**UNITED NUCLEAR**  
CORPORATION

NLS-48

Transmitted herewith is proposed Amendment 5 to SNM-777, for the  
Fuels Recovery Plant, Wood River Junction, Rhode Island.

## 302.2.9 All Purpose Hood (Equipment Number 1-L-18, Sheet Number A-602)

# 1-L-18 ALL PURPOSE HOOD SCALE $\sim \frac{3}{4} = 1'-0"$

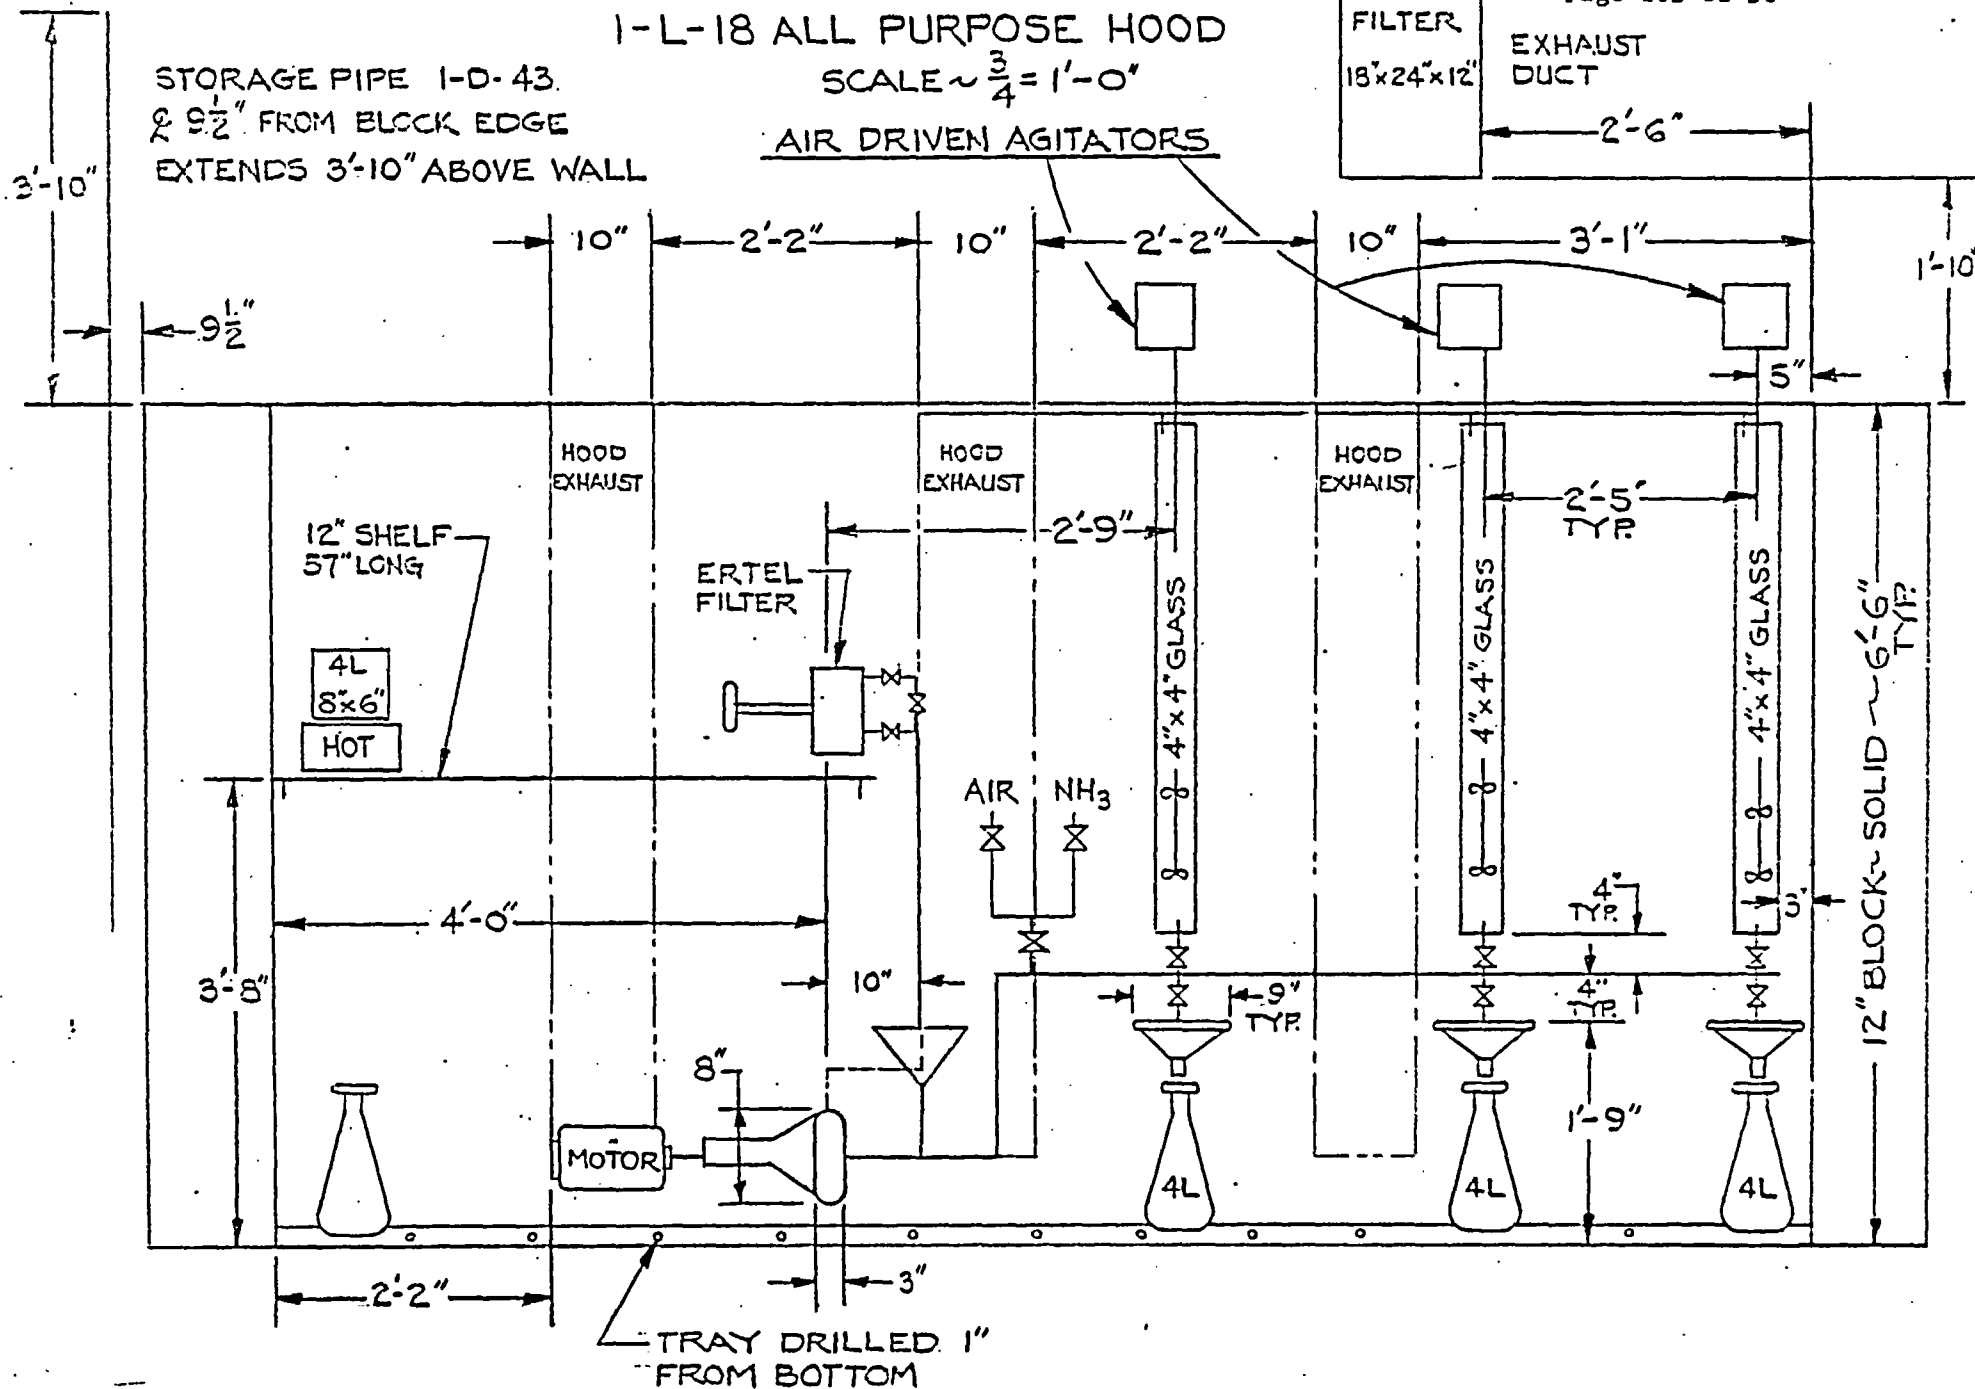
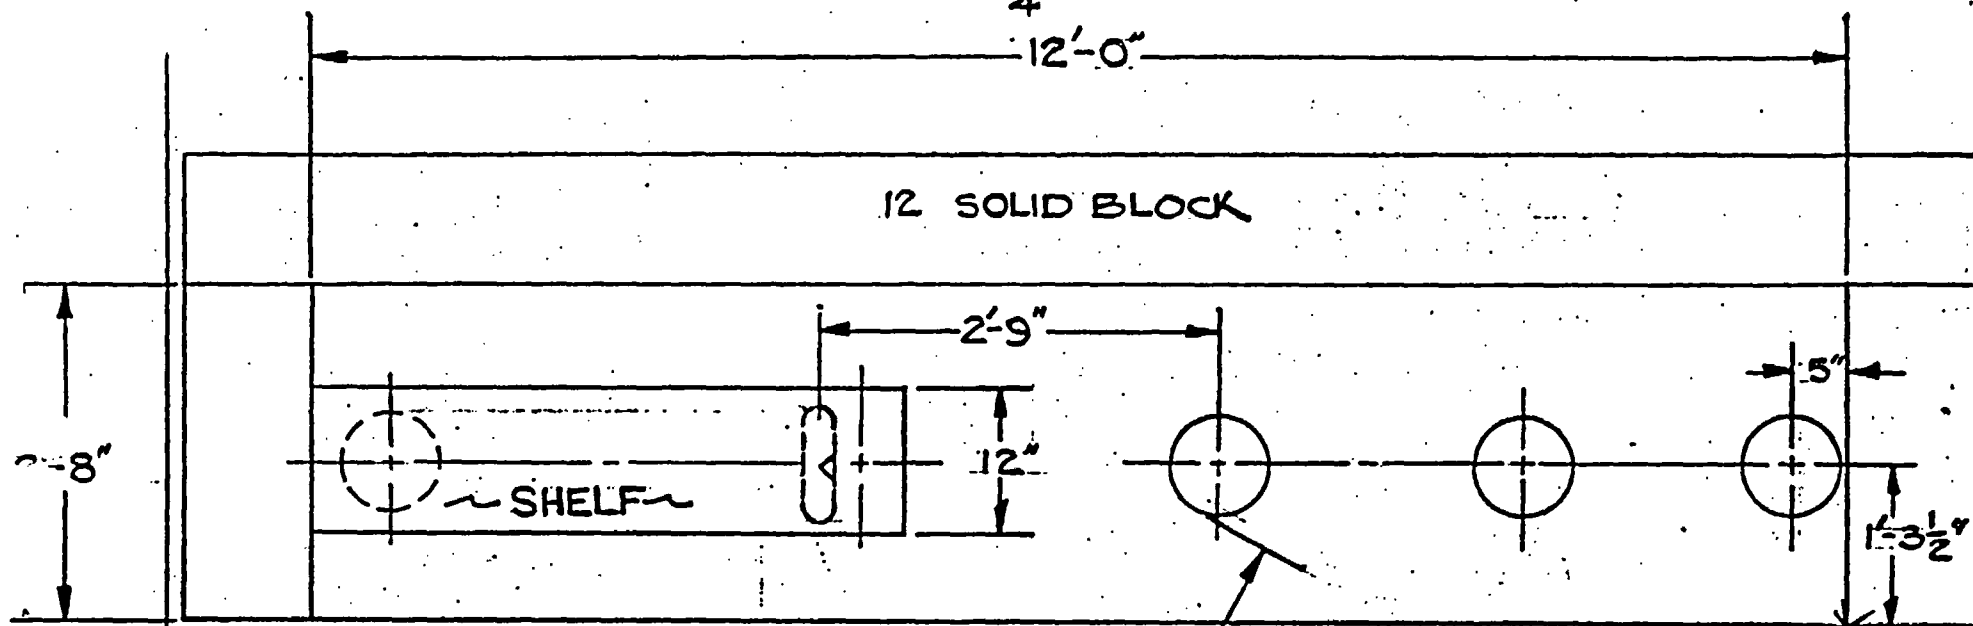
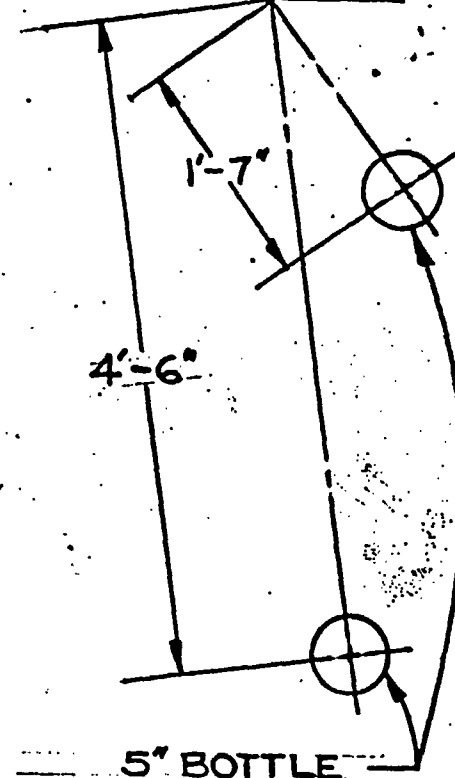
As you will note the attached pages are designed to replace  
existing section 302.2.9 in our General Information and Procedures  
Manual. These pages may, therefore, be inserted directly as re-  
vision and/or addition to our present manual.

1. This hood has a stainless steel bottom and top. The depth of the bottom is 2 inches. The 3/8" diameter holes have been drilled one inch from the bottom to overflow at one-inch solution depth.

2. Physical barriers between Buchener funnels under the columns have been installed to prevent loading at side, front, or back of each.
3. Shelf for hot plate and filter is to be 12-inches wide. Barrier installed between hot plate and filter on shelf.

4. Buchener under hot plate and beside pump to be physically isolated by barriers the same as the Bucheners under columns.
5. Position of Buchener and hot plate with 4-liter beaker are to be inter-changeable.

6. There is to be a "quick connect" line from pump discharge to fill 11-liter bottles in the portable storage cart. Since the line is near funnel which is outside the hood, an adapter will be made to cover the funnel while filling the bottle thus preventing funnel and bottle interaction.

7. Funnel has a volume of less than 4 liters of solution.
8. Air and ammonia lines pass through a check valve to prevent back-flow.
9. Buchener funnels standard 8 inches across the base, the funnel is stainless steel or porcelain, 9 inches or 10 1/2" respectively.

10. Pump volume less than 4.8 liters (see Section 301.5 of The General Information and Procedures Manual).
11. All piping inside the hood is 1/2" diameter stainless steel.

12. In the adjacent room behind the hood, there is no process piping or equipment against the column wall which is laid of 12" solid concrete blocks.

13. This hood has 1/4" thick plexiglass front panel with openings adjacent to the filters and the hot plate.
14. All exhaust air from the hood is filtered.
15. Solutions are fed to the columns through the funnel.
16. The recycle line has been connected to Tank 1-D-43. 1-D-43 connects to Assay Tanks.
17. Pan under filter and/or pump to be 1/2" in depth.
18. Agitators have steady rests at the bottom to prevent whipping action of the shaft.
19. All operations in this hood will be performed according to standard operating procedures which have had prior internal review and approval.
